PRELIMINARY SITE PLANS

AUBURN ROAD MEDICAL OFFICE

AUBURN ROAD WEST OF CROOKS ROAD
ROCHESTER HILLS, OAKLAND COUNTY, MI

Site Plan Review		
Reviewed for compliance to the City Ordinance, Building and Fire Codes		
Department	Reviewer	Approved
Planning	Kristen Kapelanski 248-841-2772 KapelanskiK@RochesterHills.org	Yes
Building	Mark Artinian 248-841-2446 ArtinianM@RochesterHills.org	Yes
Engineering	Jason Boughton 248-841-2490 BoughtonJ@RochesterHills.org	Yes
Traffic	Keith Depp 248-841-2503 DeppK@RochesterHills.org	Yes
Nat. Resources	Matt Einheuser 248-841-2551 EinheuserM@RochesterHills.org	Yes
Fire	Capt. Ann Echols 248-841-2701 EcholsA@RochesterHills.org	Yes
<p align="center">City of Rochester Hills Planning & Economic Development</p> <p align="center">Conditions and mark-ups noted throughout the plan set must be addressed prior to final approval.</p>

DRAWING TITLE
PRELIMINARY LANDSCAPE PLAN

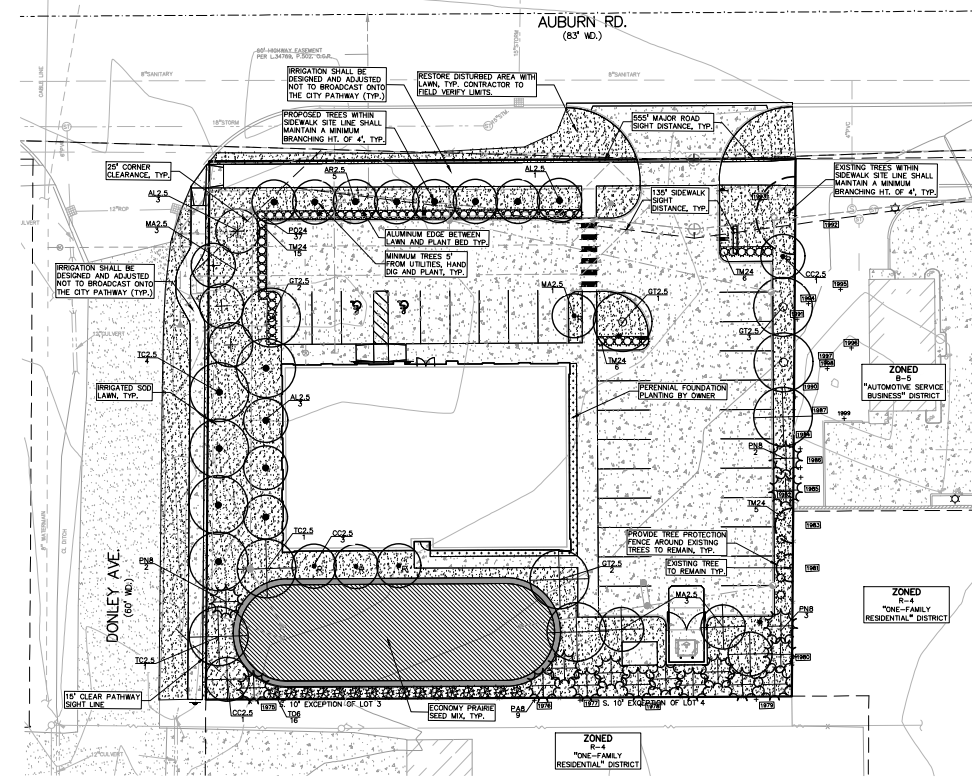
The Planning Commission can modify landscape requirements and will rely heavily on the adjacent neighbor's wishes for landscape screening.
